ADDENDUM

A New Food Bank & Youth Center Finish Out
For Culberson County
Van Horn Texas

Addendum No.: **Six (6)**

Project No.: 09128

SD-3

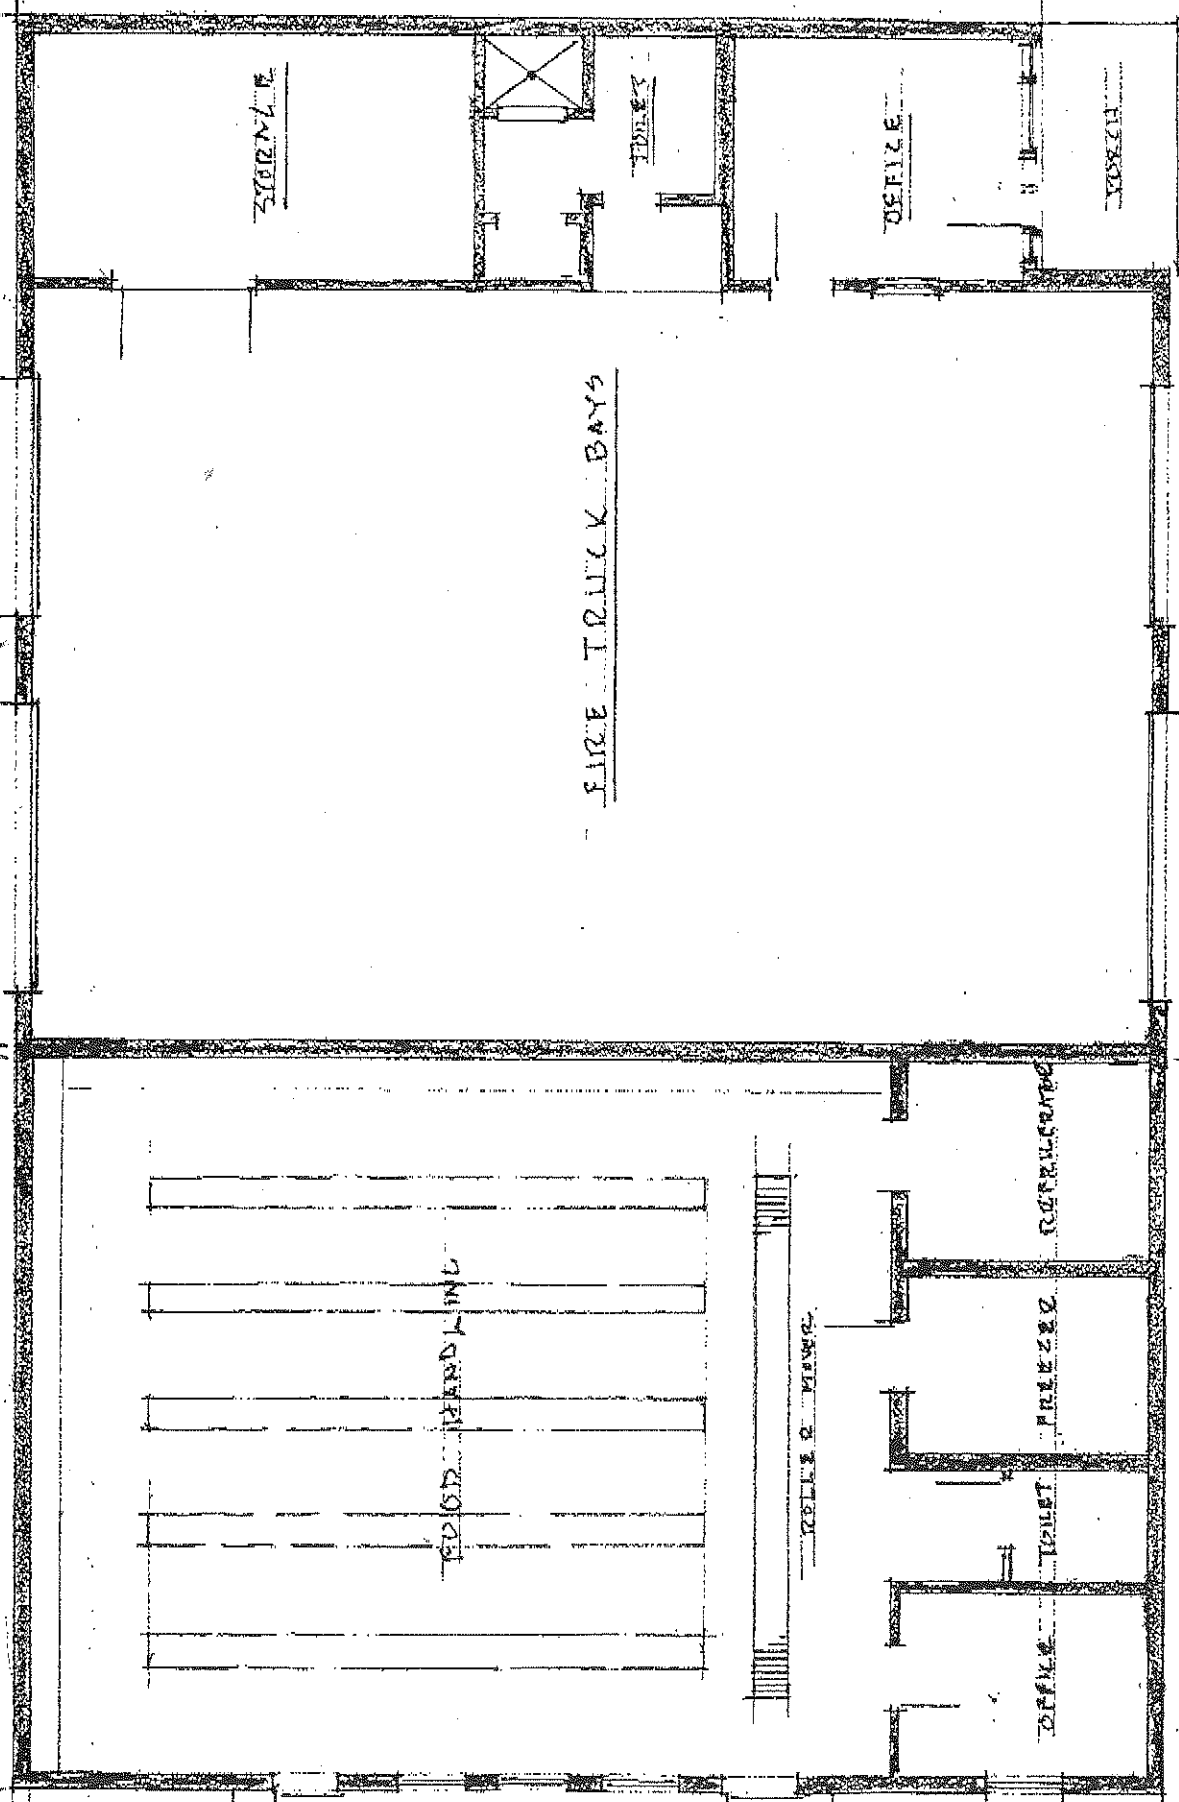
Item No. Two: Alternate #2.9: Combine the food bank and the fire station into one building. See attached supplemental drawings SD3, SD-4 and SD-5. Notice that the roof structure of the food bank will be supported on the east-side by the rigid frames and/or the steel columns of the fire station. Provide 4'x4'x2' piers under west wall rigid frames for food bank.
